**LSDP, Duluth Trading Co
STAFF SUMMARY REPORT**

LOCATION:	3200 S. 27 th Street
LAND OWNER:	Agg Investments, LLC
DEVELOPER:	Oppidan
APPLICANT/ ENGINEER:	GreenbergFarrow
ZONING DISTRICT:	C2 (Highway Commercial)
PLANNED USE:	Retail Sales
REQUEST:	Large-Scale Development Project approval
AUTHORITY:	Article III of Chapter 14, Rogers Code of Ordinances
DESCRIPTION:	15,656-sf retail building on 2 acres
WAIVERS:	Yes: Overlay District required landscaping areas, Overlay District tree spacing, 18'x18' tree islands, and maximum number of permitted driveways

Project Duluth Trading Company
3200 South 27th Street
Rogers, AR 72758
Waiver Letter
Project# 20180593.0

C2.0

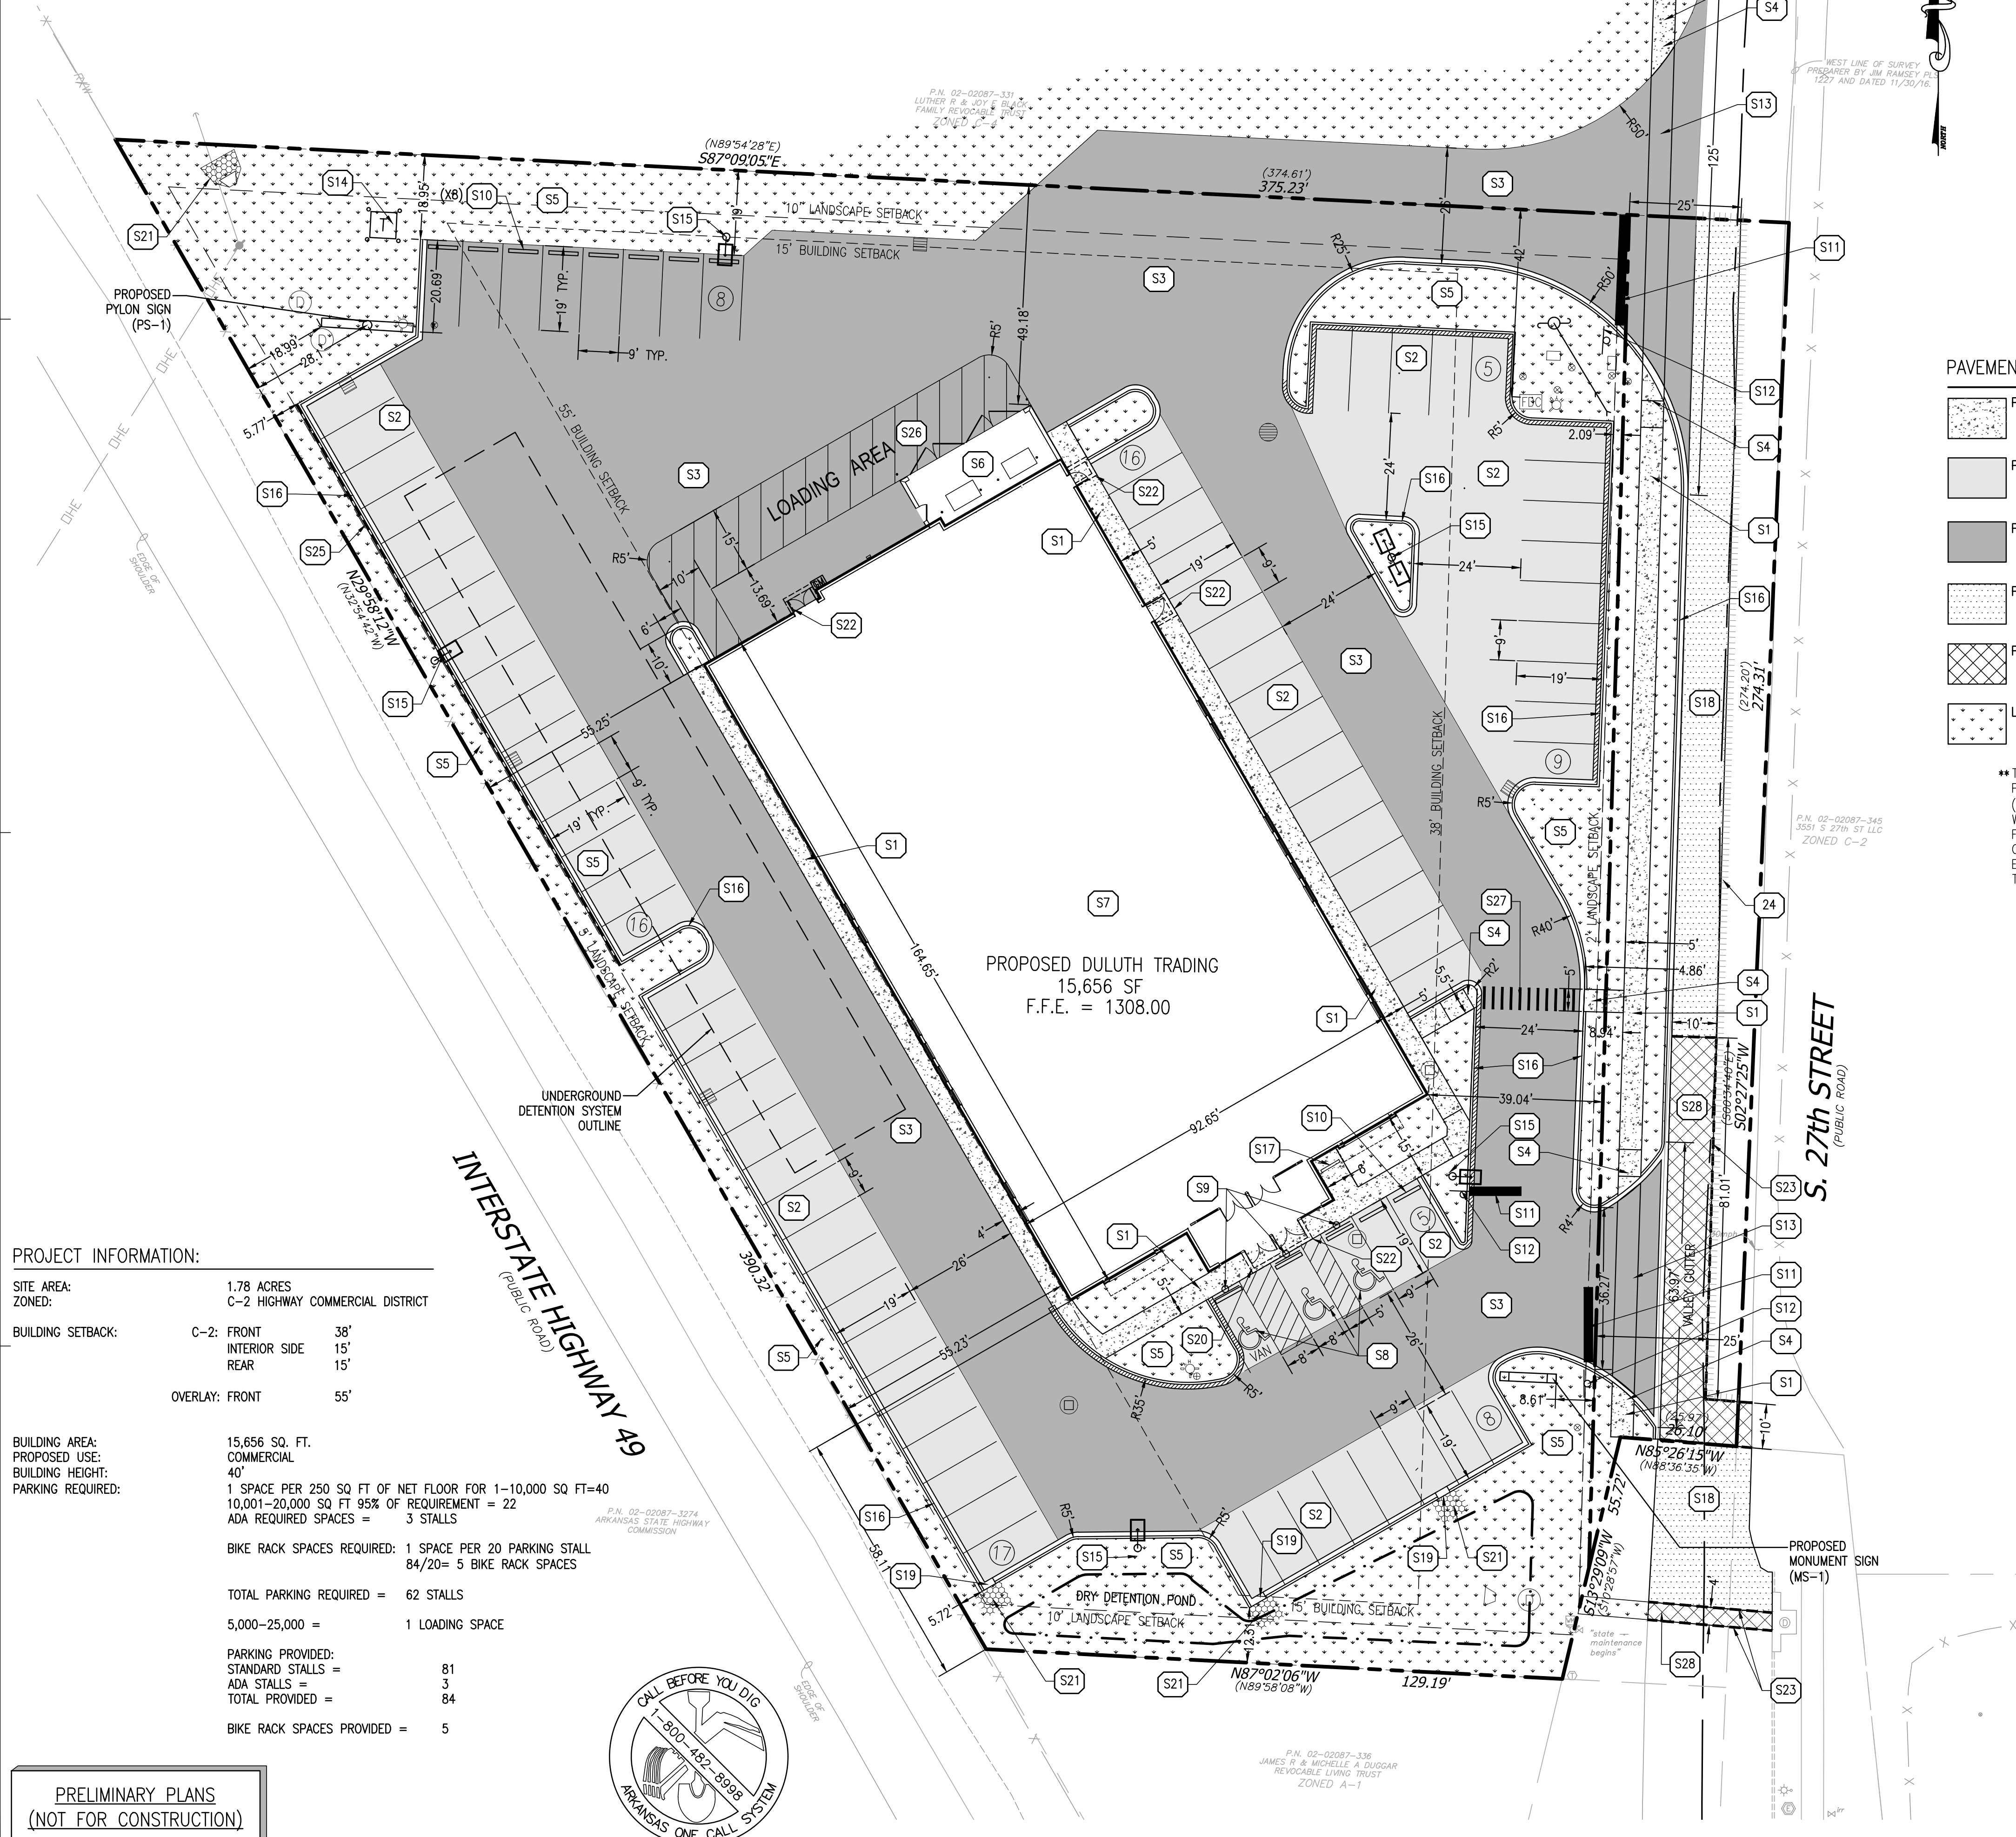
- 1) Access Management: The applicant requests a **WAIVER** to Sec. 14-260(1)E – Number of curb cuts permitted because the applicant states that the second access is needed for circulation and business' operation to successfully function. One driveway is proposed to be a shared access driveway with the property to the north of the applicant's site and a second driveway is for the access to the applicant's site only.

- b) Water quality: Water quality will be addressed by a Contech CDS-2015-4 water quality unit.
- 3) Large Scale Development Regulations:
 - a) Tree Islands: The applicant requests a **WAIVER** to Sec. 14-256(14)B(b) – (18'x18') Tree Islands. The applicant has proposed to eliminate two required tree islands and provide one reduced 19'x9' tree island because of the site's unique shape is unable to construct a parking lot with sufficient parking spaces.

- a) **Deny waiver to Sec. 14-260(1)E – Number of curb cuts permitted.** One (1) curb cut is permitted for 600' or less of street frontage. The site has approximately 330' of street frontage along 27th Place. Staff does not consider the lot size in comparison to the size of the development as a hardship to justify the waiver.
 - b) **Deny waiver to Sec. 14-256(14)B(b) – Tree Islands.** Two tree islands are required based on the proposed parking lot layout. Staff does not consider the lot size in comparison to the size of the development as a hardship to justify the waiver.

Per the Large Scale Development Plan review comments (dated July 5, 2018), City Staff would like the site to address this comment, "An 18'x18' tree island is required for every 15-parking spaces, per sec. 14-256(14)b." Duluth Trading Company respectfully requests a tree island waiver, based on the following project hardships and site restraints:

Per the Large Scale Development Plan review comments (dated July 5, 2018), City Staff would like the site to address this comment "Only one driveway is permitted per sec. 14-260(1)e. Please revise or request a waiver from this section of City code." Duluth Trading Company requests a driveway waiver, based on the following project hardships and site restraints:

- On account of the property's unique shape, the site is unable to construct a parking lot with sufficient parking stall quantities, therefore, the addition of an 18-foot by 18-foot tree islands would eliminate valuable parking

stalls for a business that is already deficient from their prototypical needs. Since the proposed development is proposing an extensive amount of landscaping improvements to the site's interior planting islands and planting beds, as well as, a significant amount of trees to the site's exterior perimeter, we believe that the project's landscape request for waiver will not affect or jeopardize the public's health, safety and welfare. Duluth Trading Company respectfully requests that the Planning Commission grant a waiver for (1) 9-foot by 19-foot tree island along the site's western parking field.

- In order for the development's circulation and business' operation to successfully function, the site will require 2-driveways. Reducing the number of entry drives will significantly alter the project's proposed site plan, in order to accommodate visiting motorist, semi deliveries and trash pick-up, therefore, eliminating additional parking stalls from the development. Also, the proposed development will comply with the City code's driveway distance requirement, which is a minimum of 100-feet between curb cuts. Additionally, Planning Staff has requested that the project propose a 2nd driveway to be located along the northern property line. This 2nd driveway was to be a shared entry drive to for use by Duluth Trading Company and the future development to the north. The two (2) driveways are to be located on a minor street (South 27th Street). Duluth Trading Company believes that an additional curb cut on site will not affect or jeopardize the public's health, safety and welfare. Duluth Trading Company respectfully requests that the Planning Commission grant a waiver for 2 driveways/curb cuts along South 27th Street.
